Product Change Notification

PCN-TT-1169-2018

Business Unit	Product Line Code	Type of Change	Action	Date of Issue
TT - Trabtech	CL1	Product Change	Notify Distributors and	2/2/2018
		Notification	Field

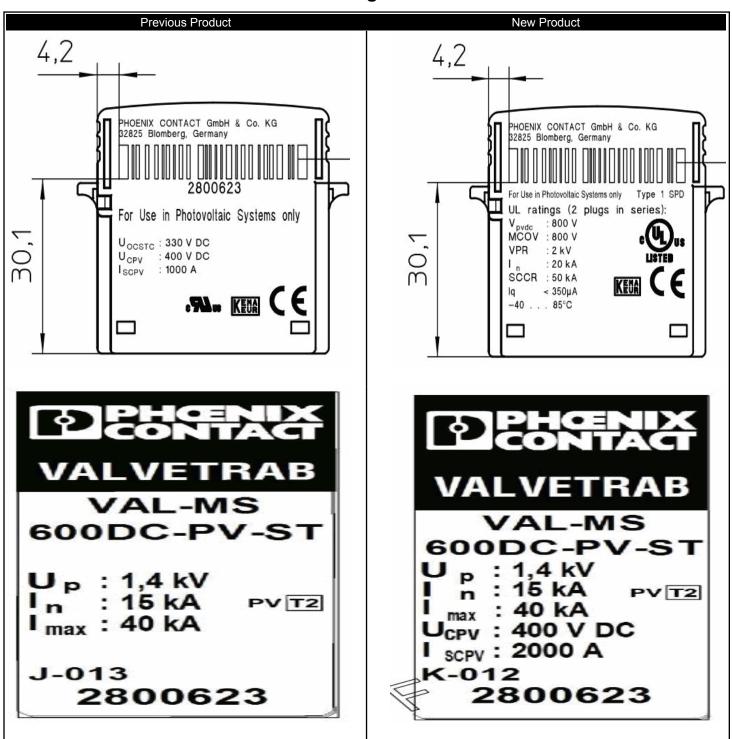
All VAL-MS ...PV SPDs were required to be updated in accordance with UL 1449 Ed. 4. During this update the products received a UL listed rating for the 600VDC T1/T2 and T2 types. All of the PV SPDs 1000VDC T1/T2 and T2 are UL recognized 1CA. The short circuit current rating has increased from 1000A to 2000A which is shown on the top label of the product. Specific UL data is also included on the label on the side of the plug.
